ADDENDUM NO. 1
February 6th, 2025

PROJECT: TRI-TRY WSC
PUMP STATION IMPROVEMENTS

The following changes and/or additions shall be made to the Plans, Specifications, and Contract Documents for the above referenced project. Bidder shall acknowledge receipt of this Addendum by signing below and returning this Addendum with the Bid.

ASPERMONT, TEXAS
 TRI-TRY WATER SYSTEM IMPROVEMENTS
 BUILDING ELEVATIONS

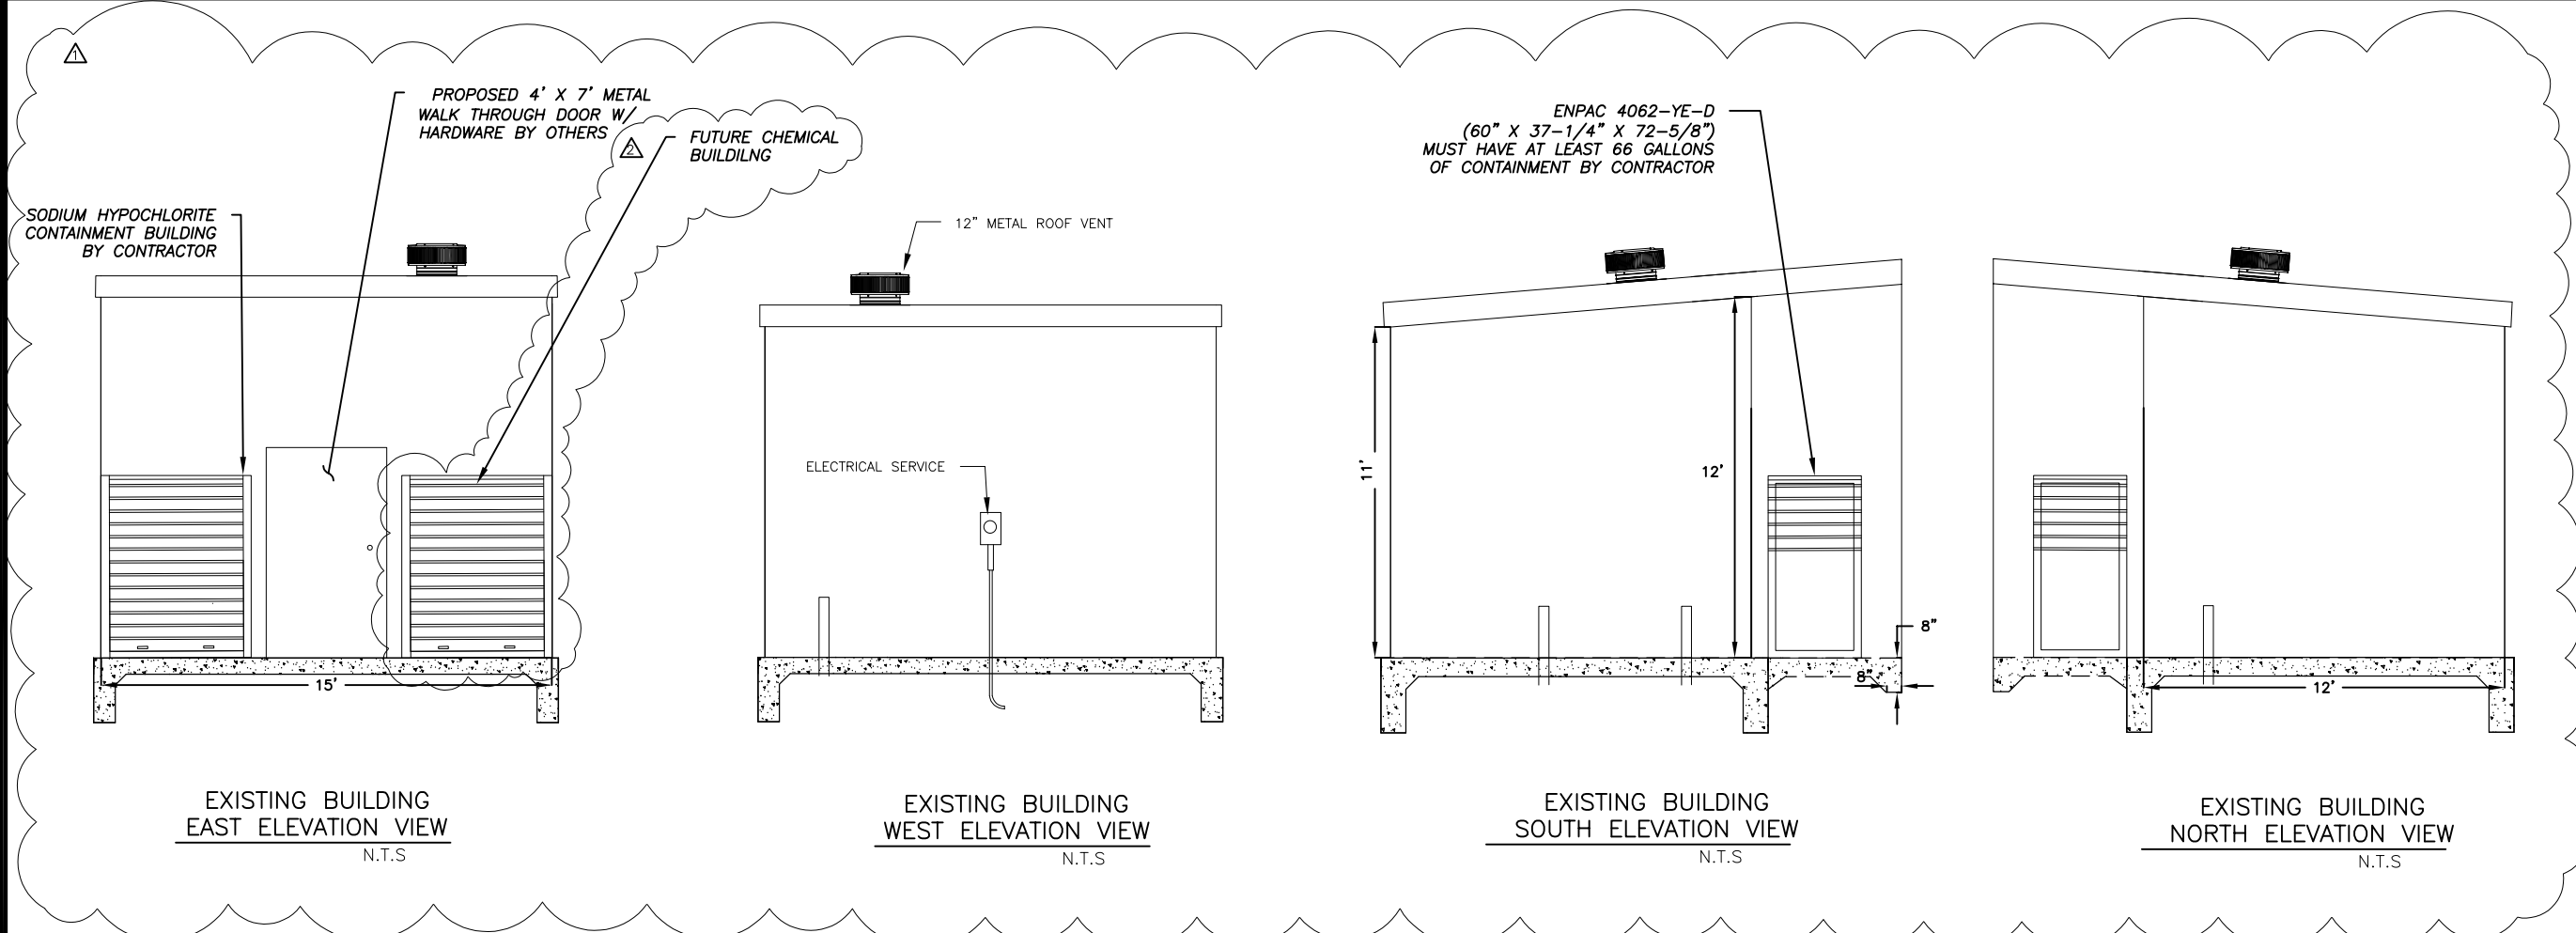
Sheet 11 – Building Elevations – This sheet has been modified to update the building orientation and provide additional details on the pump station building -- by others.

NOTE:
 1) 15'X12' STORAGE BUILDING, BUILDING FOUNDATION, CONCRETE BUILDING PAD, DOORS, BUILDING INSULATION AND FURNISHINGS SHALL BE INSTALLED BY OTHERS
 2) CONTRACTOR WILL BE RESPONSIBLE FOR ALL ELECTRICAL APPURTENANCES AND FACILITIES AS SHOWN IN THIS PLAN SET.

ASPERMONT, TEXAS
 TRI-TRY WATER SYSTEM IMPROVEMENTS
 STORAGE TANK PLAN AND ELEVATION

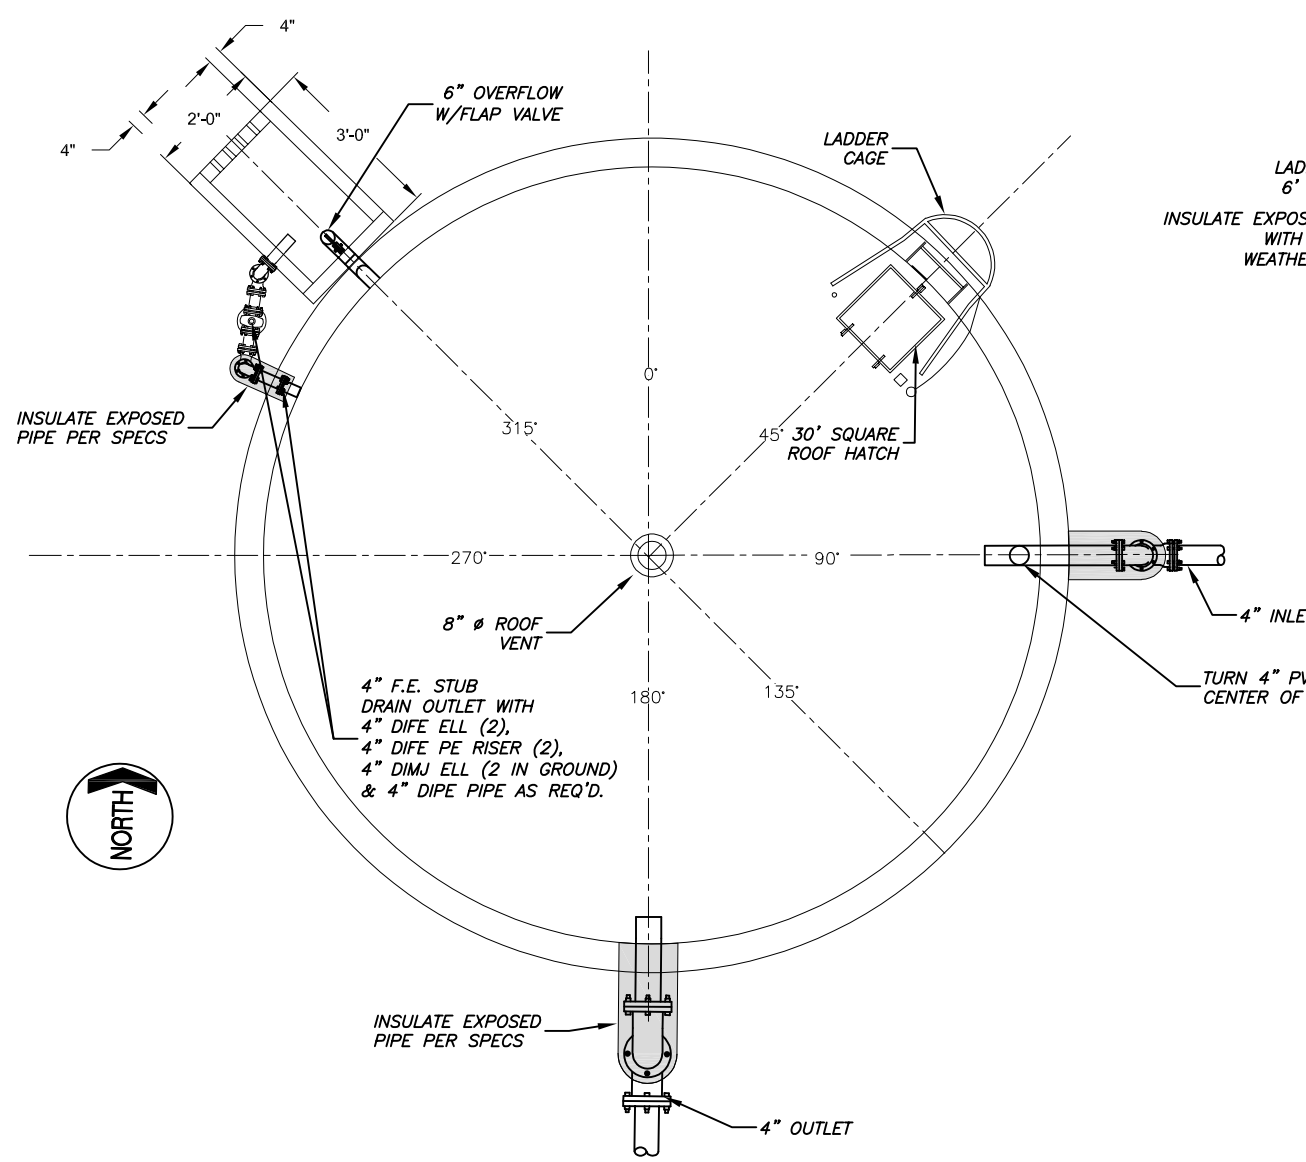
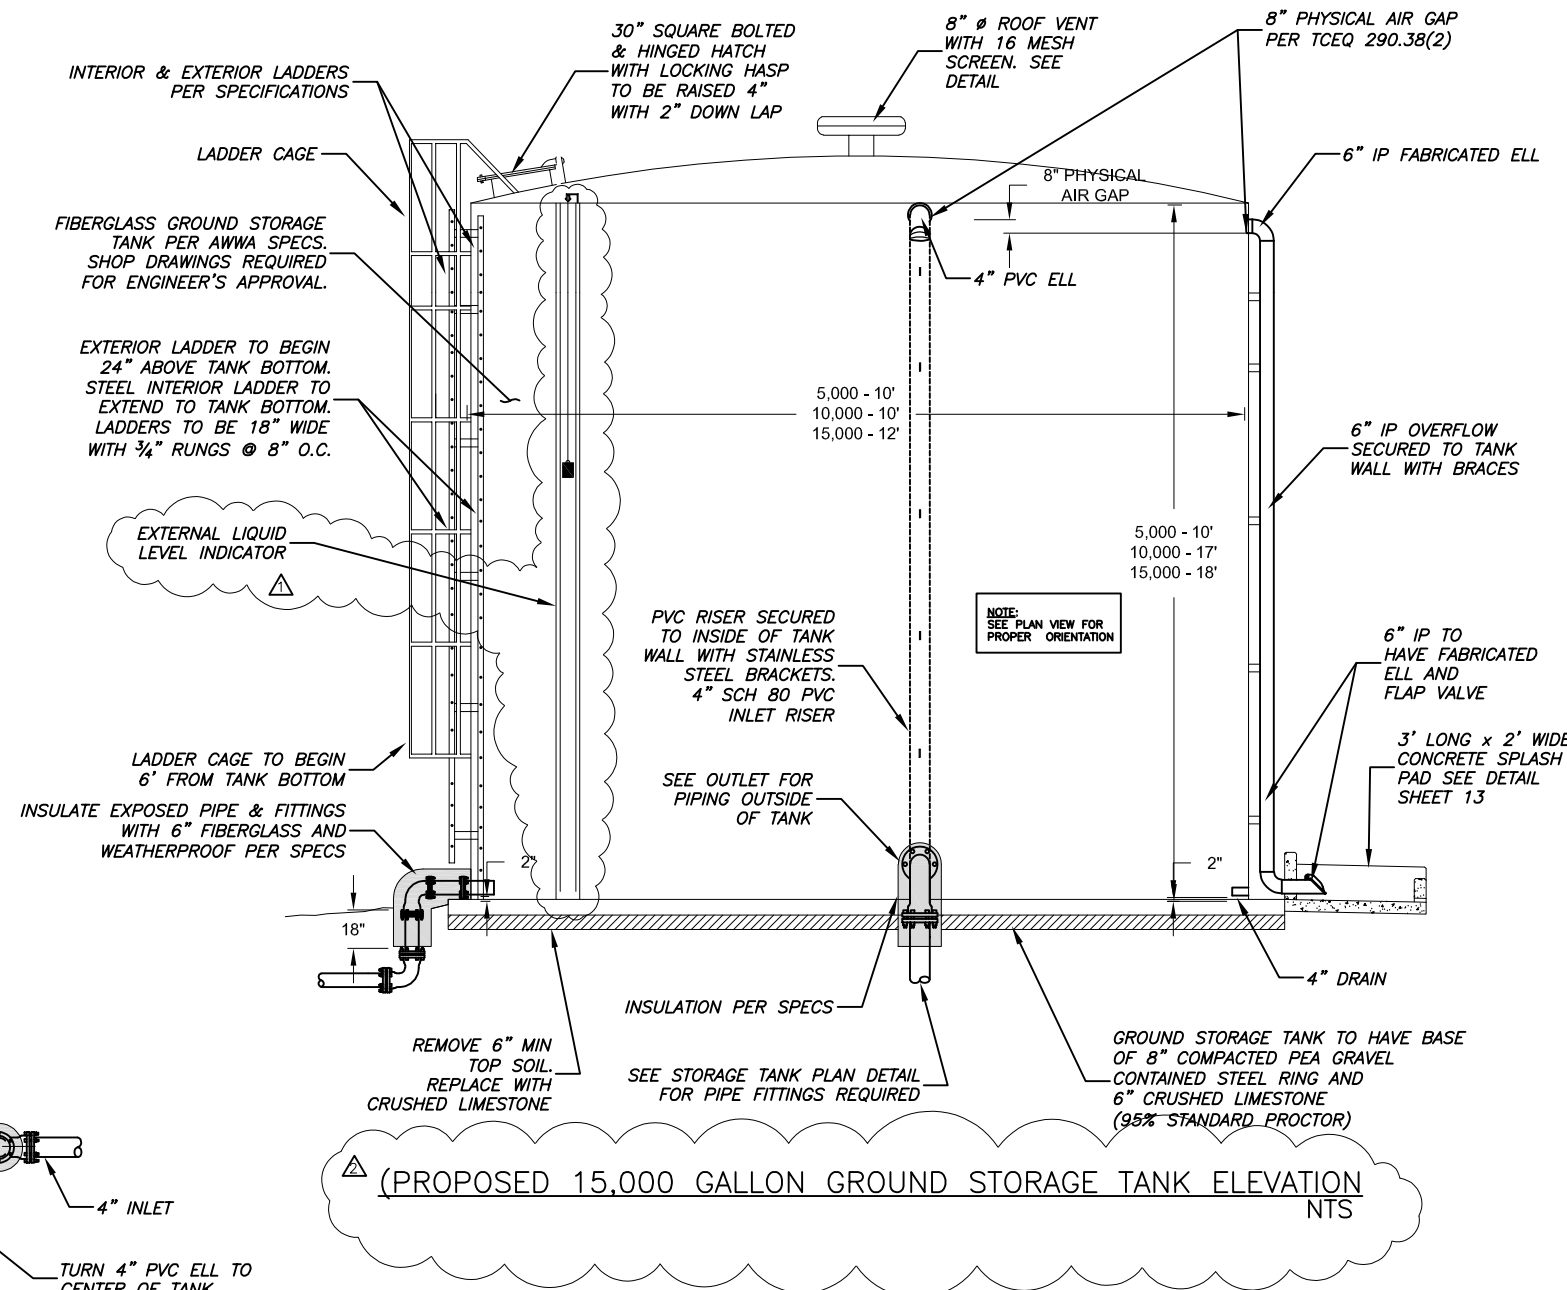
Sheet 12 – Storage Tank Plan and Elevation – This sheet has been modified to clarify the tank details and the tank additive options.

NOTE:
 BASE BID - 15,000 GALLON FIBERGLASS TANK
 ADDITIVE ALTERNATIVE 1 - 5,000 GALLON FIBERGLASS TANK
 ADDITIVE ALTERNATIVE 2 - 10,000 GALLON FIBERGLASS TANK
 ADDITIVE ALTERNATIVE 3 - 15,000 GALLON STEEL TANK
 ADDITIVE ALTERNATIVE 4 - 10,000 GALLON STEEL TANK
 ADDITIVE ALTERNATIVE 5 - 5,000 GALLON STEEL TANK
